Memo

To: Amy Moon, EFSEC; Ami Hafkemeyer, EFSEC
From: Dave Kobus, Scout Clean Energy
Cc: Tim McMahan, Stoel Rives; Pat Landess, Scout Clean Energy; Linnea Fossum, Tetra Tech; Troy Rahmig, Tetra Tech
Date: August 9, 2023
Subject: Horse Heaven Wind Farm Anticipated Project Modifications for Final Application for Site Certification

EXECUTIVE SUMMARY

Horse Heaven Wind Project

Overview Map Turbine Layout Option 1

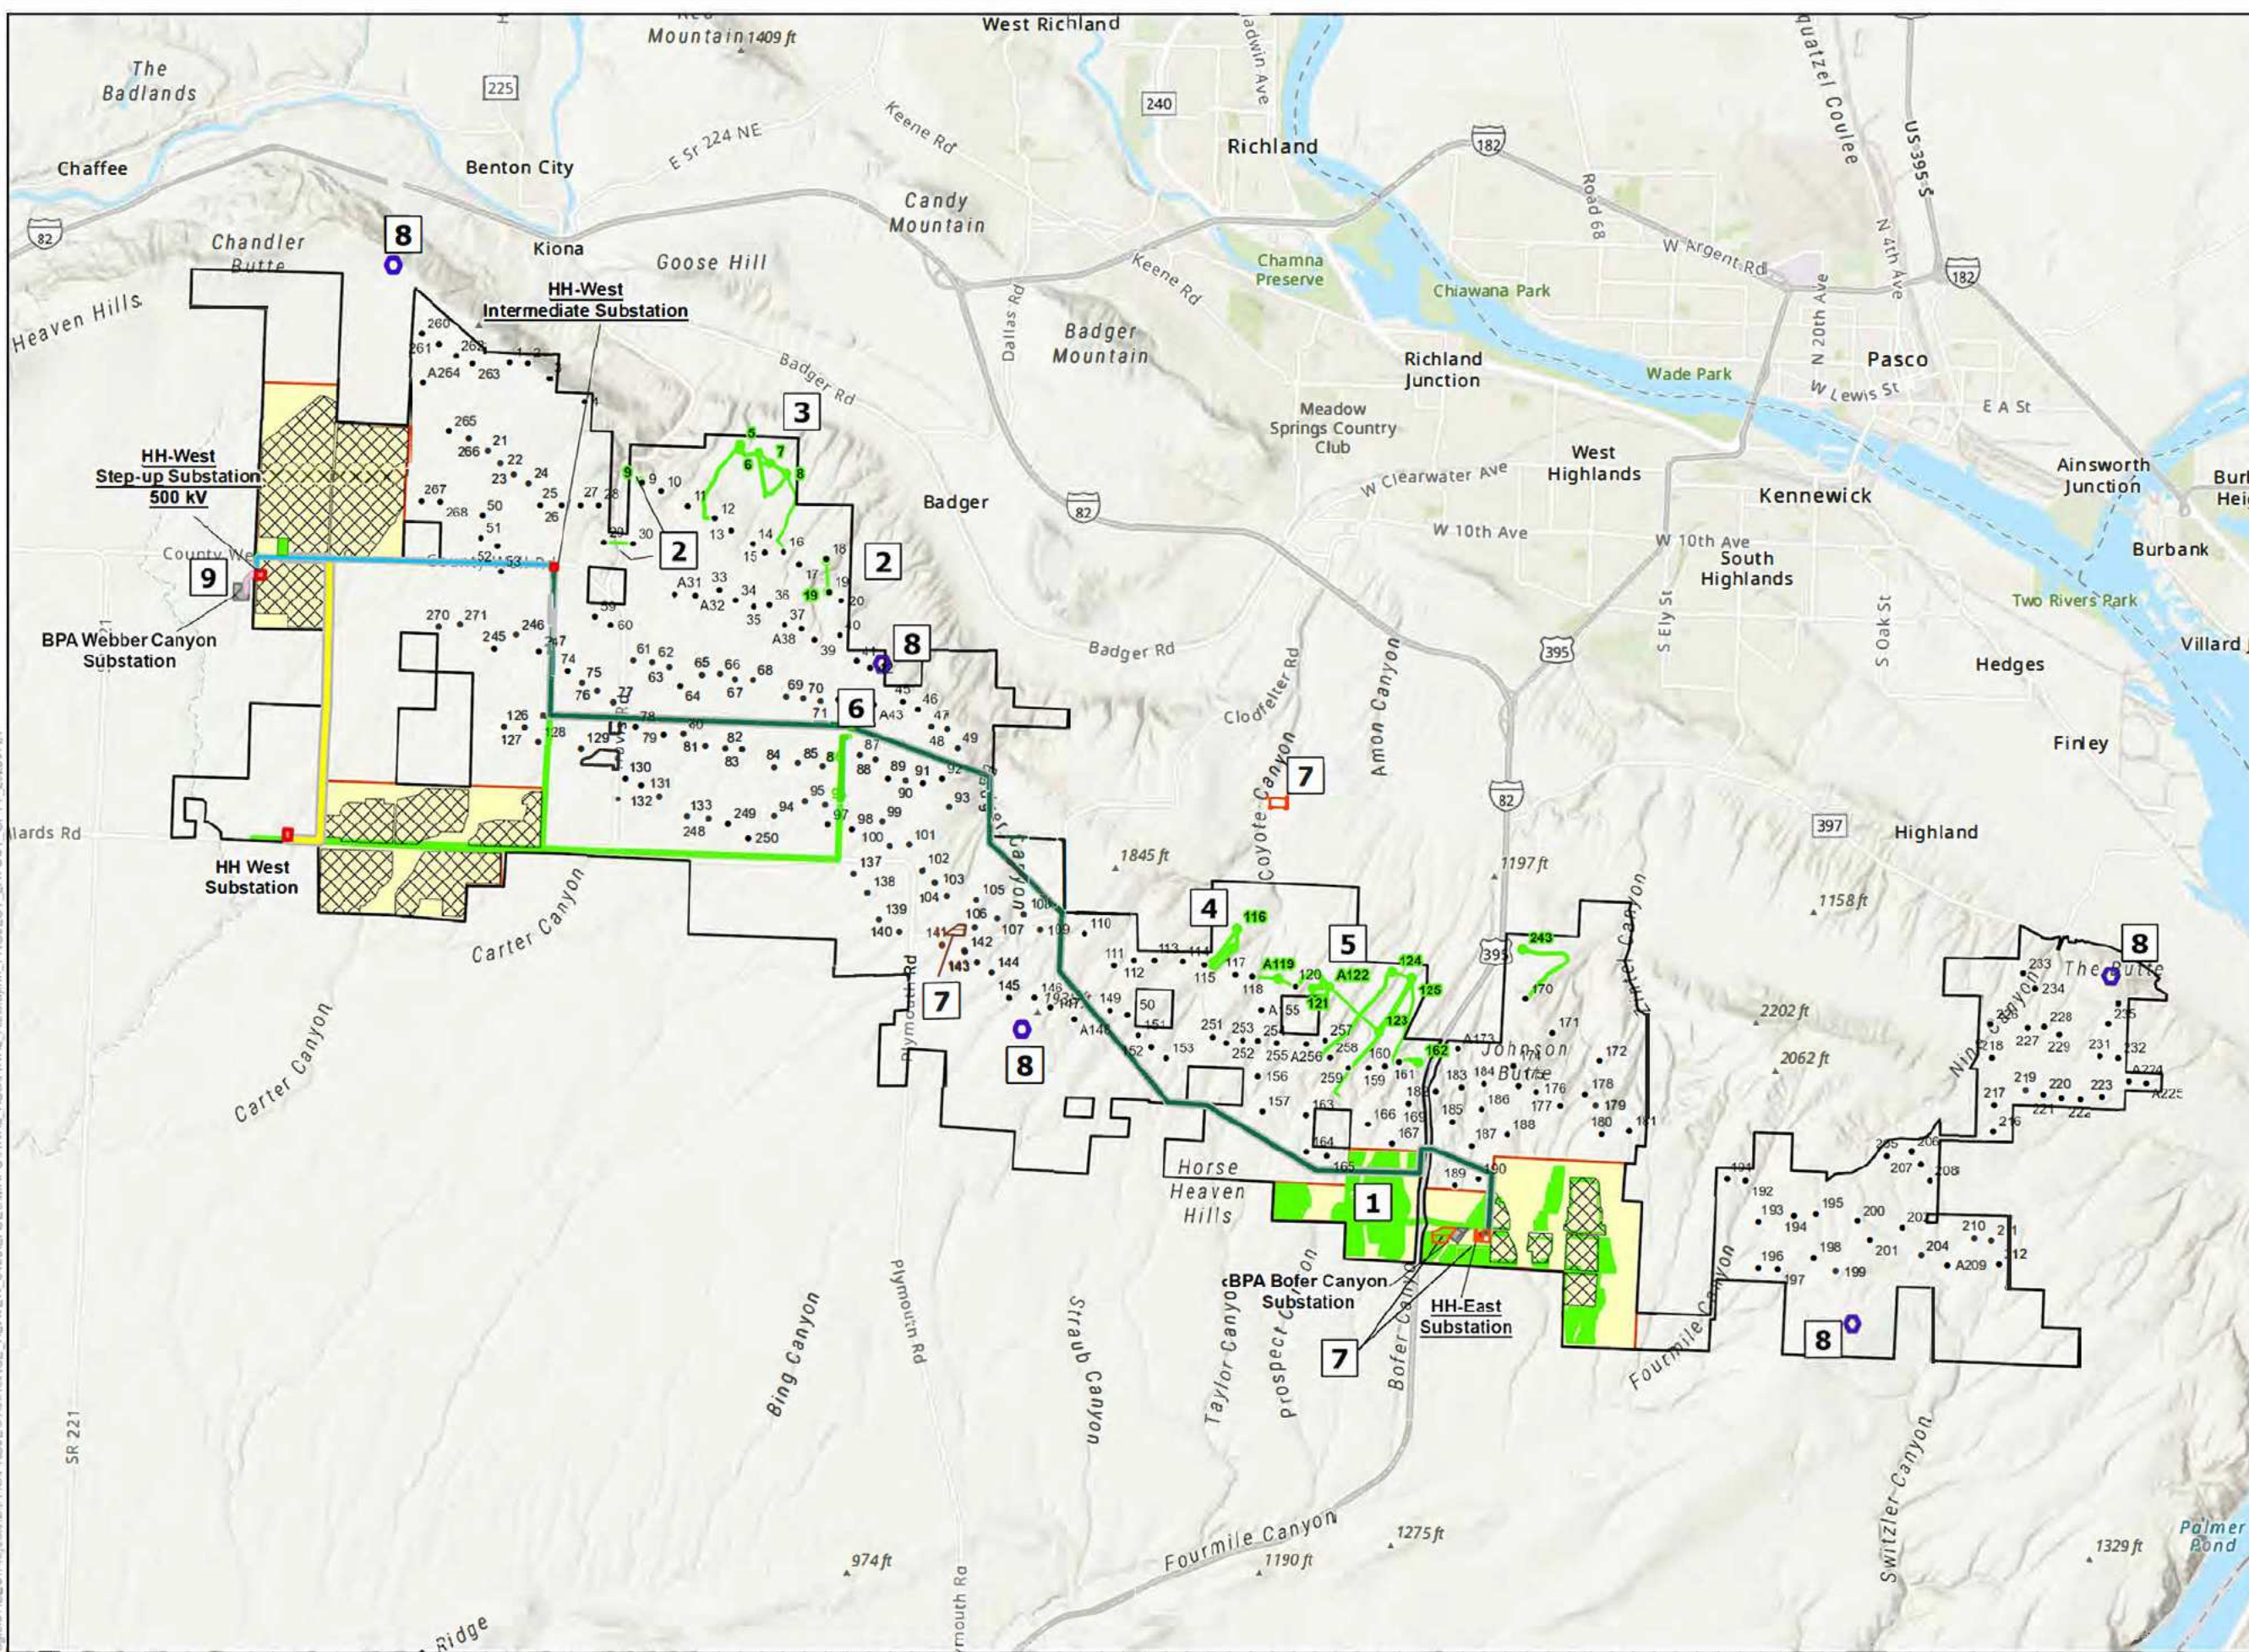
Planned modification: Remove all solar array infrastructure west of I-82; remove solar infrastructure within approximately 1 mile of I-82 on the east (see area '1' on attached overview map, Attachment 1). This modification will reduce the acreage of the fenced area for this array by approximately 1,398 acres, leaving a total of approximately 639 acres of fenced solar panels. This change will remove infrastructure that would have disturbed Priority Habitats, including rabbitbrush shrubland habitat, in the portion of this array originally proposed west of I-82. Note that temporary disturbance to Priority Habitat areas east of I-82, including temporary laydown areas, will still occur, but there will be no permanent impacts to Priority Habitats in the East Solar Area with this change.

Planned modification: Collector lines and Turbines have been moved farther away from Webber and Sheep canyons (see area '2' on attached overview map). Turbines 8, 18, and 19 were shifted as much as possible from canyon rims while remaining within the bounds of the Department of Defense Mitigation Agreement; see Table 1 for new turbine coordinates. In addition, collector lines originally planned to span the canyons have

Planned modification: Remove Turbines 5, 6, 7, and 8 from the proposed layout (see area '3' on attached overview map; see Table 1 for coordinates of Turbines removed from the layout).

Planned modification: Remove Turbine 116 from the proposed layout (see area '4' on attached overview map; see Table 1 for Turbine coordinates).

Planned modification: Remove Turbine's 119, 121,122, 123, 124, 125, 162 & 243 (see area '5' on attached overview map; see Table 1 for Turbine coordinates) from the proposed layout.

Planned modification: Remove primary intermediate substation and associated 230-kV and 500-kV transmission line infrastructure; remove step-up substation on Sellards Road (see area '6' on attached overview map).

Planned modification: Add locations for Phase 1 and Phase 2 construction laydown; add interim Turbine component laydown area (see area '7' on attached overview map).

Facility Infrastructure Comparison Turbine Layout Option 1 Map 4 of 11

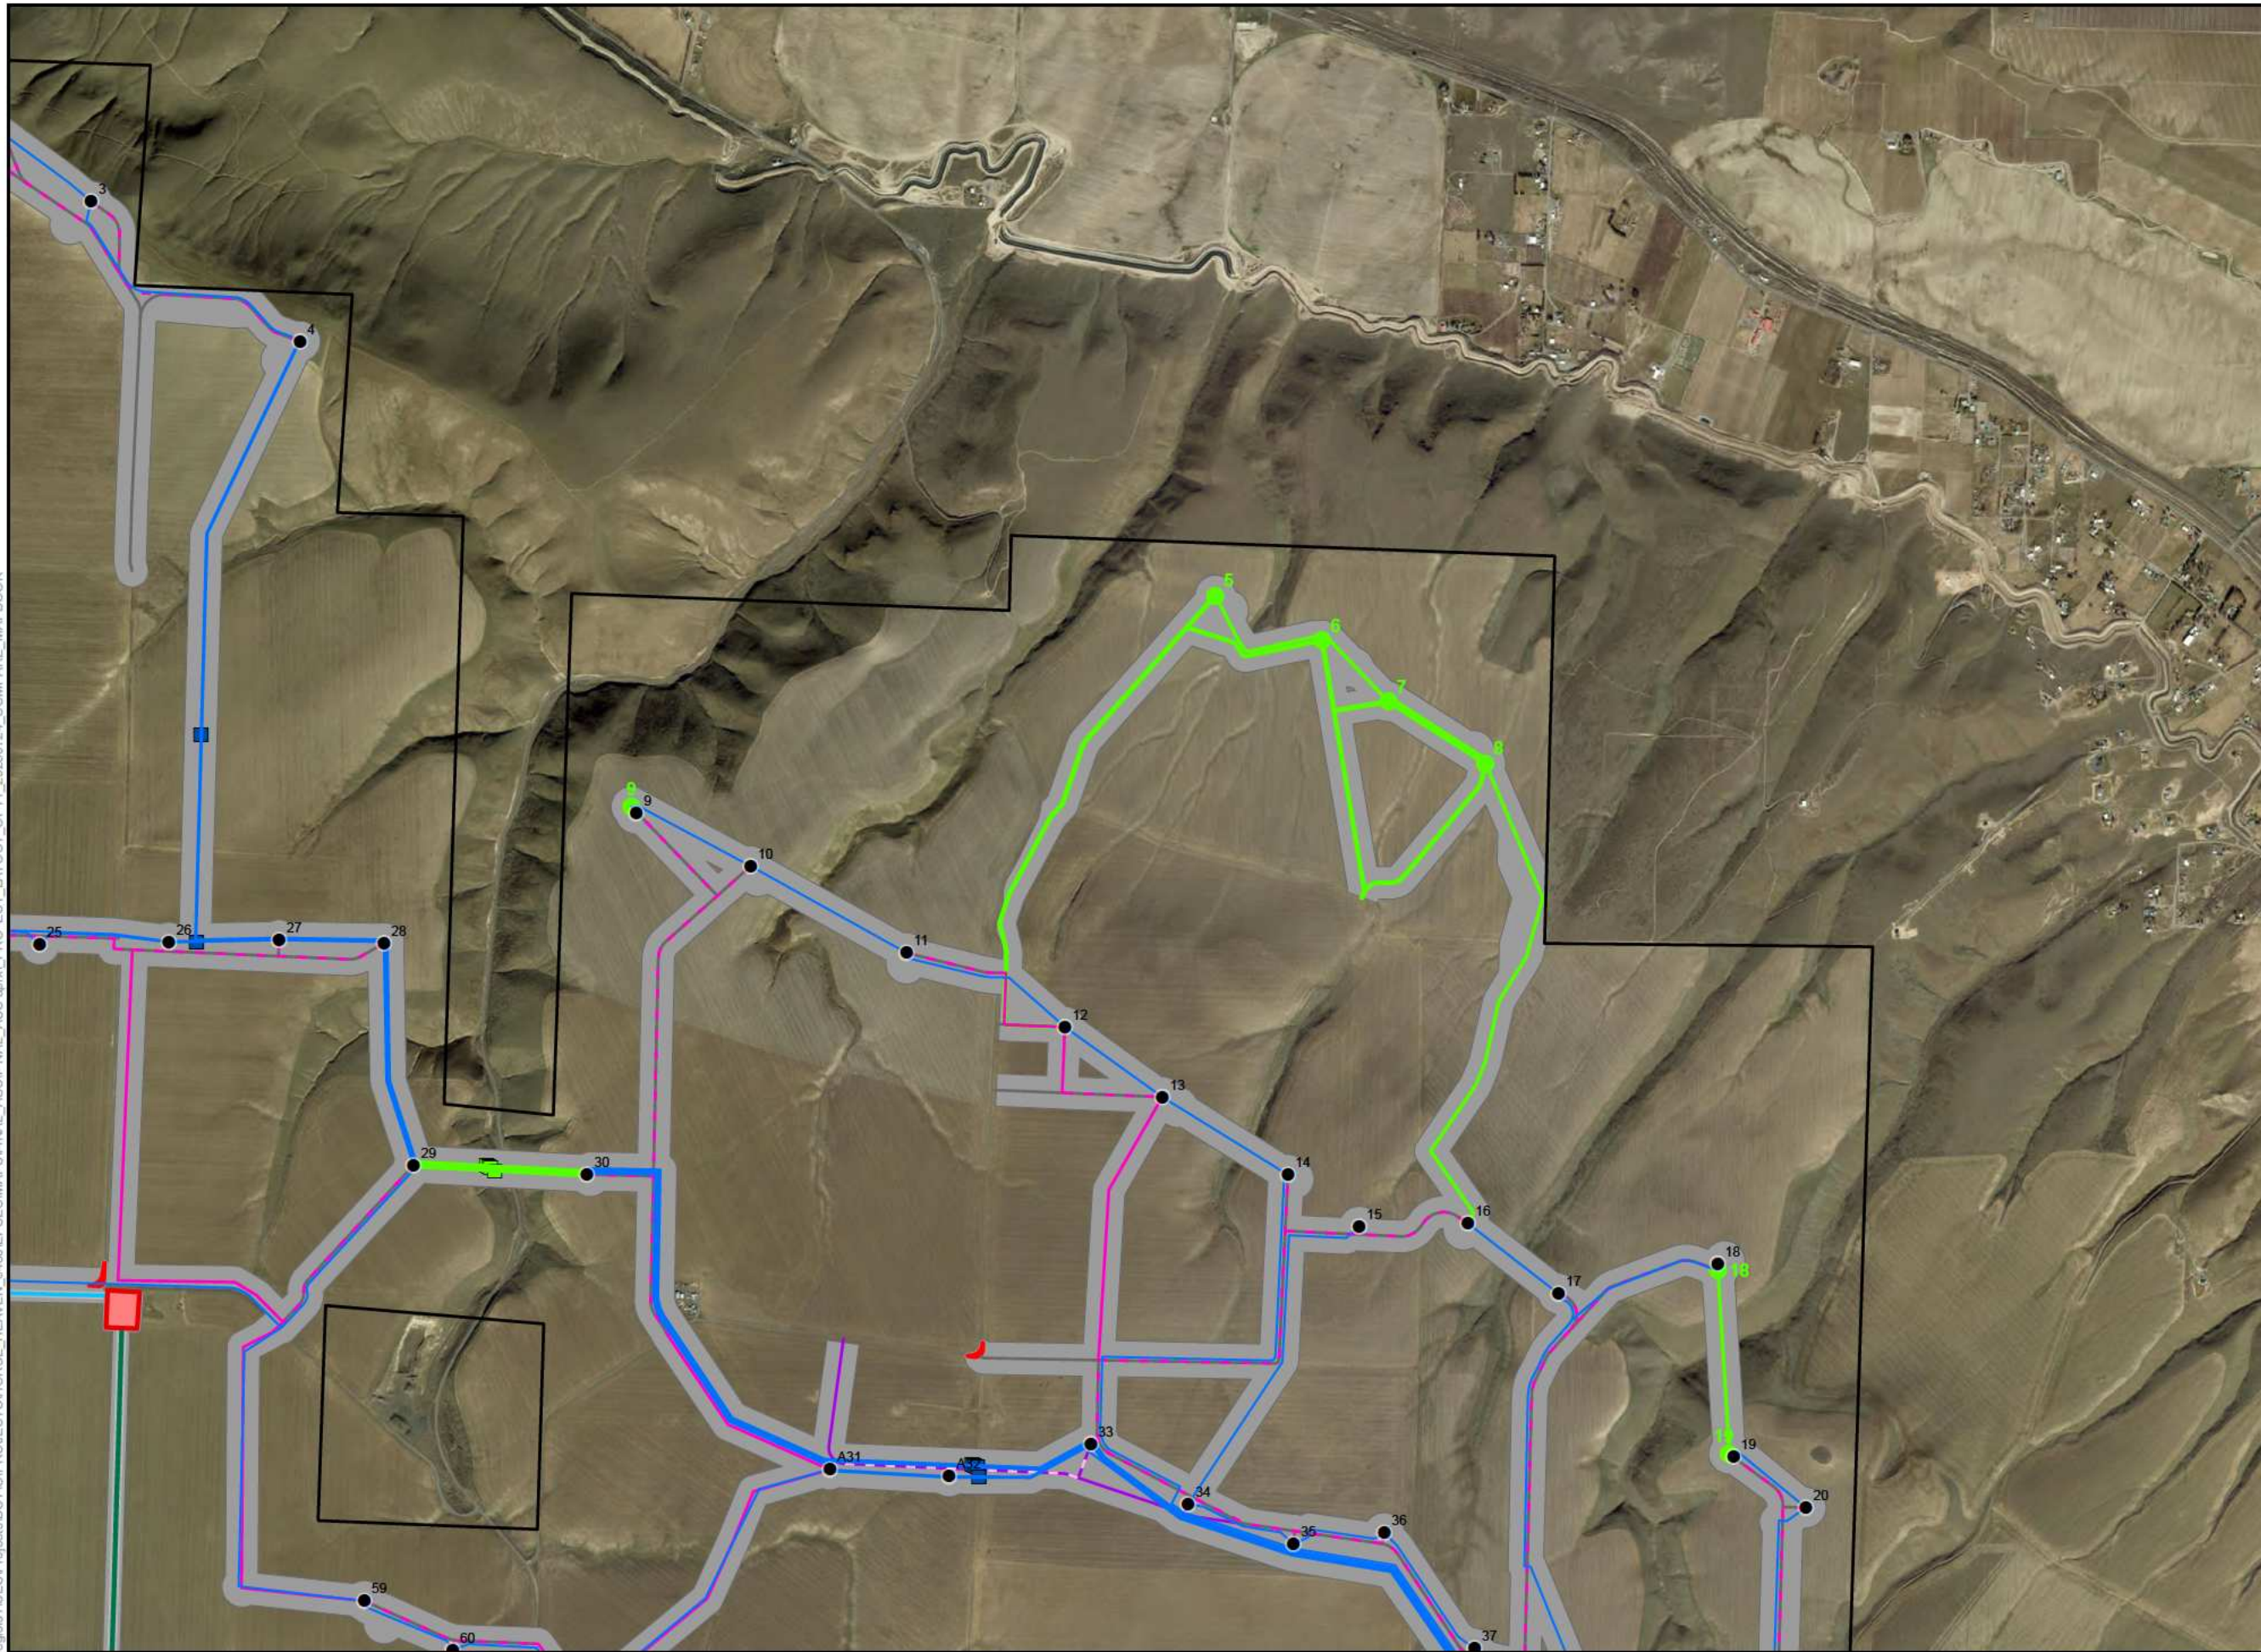
Planned modification: Extend the County Well Road 500-kV transmission line route to begin at the Intermediate Substation (p. 4 of Infrastructure Comparison mapbook, Attachment 1) to BPA’s planned new Webber Canyon substation. Although the line will now extend slightly further to the south and west to reach BPA’s planned new Webber Canyon substation location, immediately west of the Project site boundary, the majority of approx. 4 miles is being upgraded from 230 kV to 500 kV. Modify HH-West Project Substation and battery energy storage location to be closer to the new BPA substation but within the previously surveyed

Gould Well Location

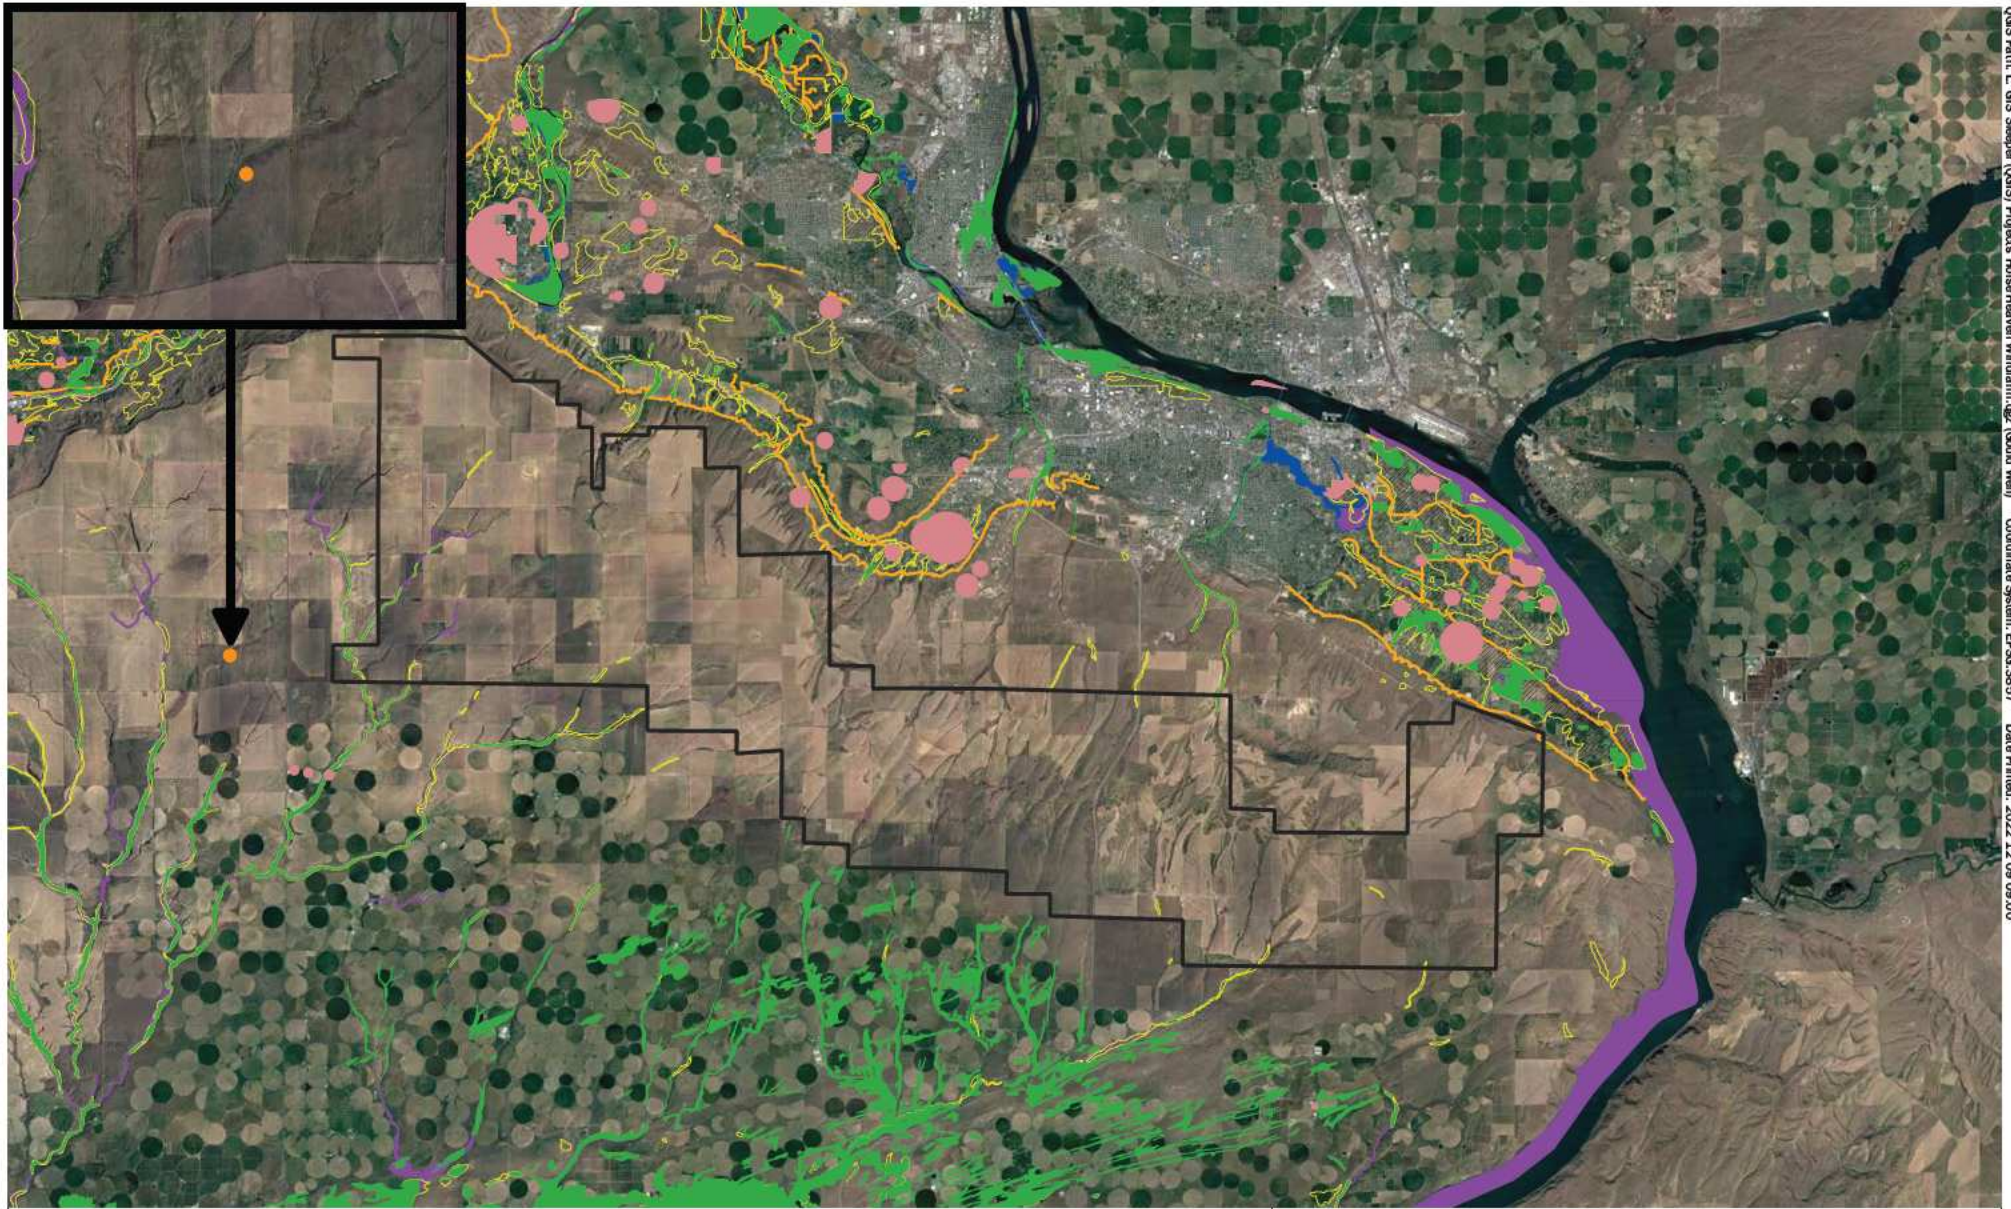
Planned modification: Scout is currently working with DNR to assess the potential for a lease agreement that would allow for use of a portion of DNR's existing water right associated with the Gould Well to be used during construction and operation of the Project. The Gould Well is located approximately 2 miles west of the Project lease boundary; see map in Attachment 3. The lease agreement, payment, and any necessary well improvements would be handled through a SEPA process to be conducted by DNR as a separate action
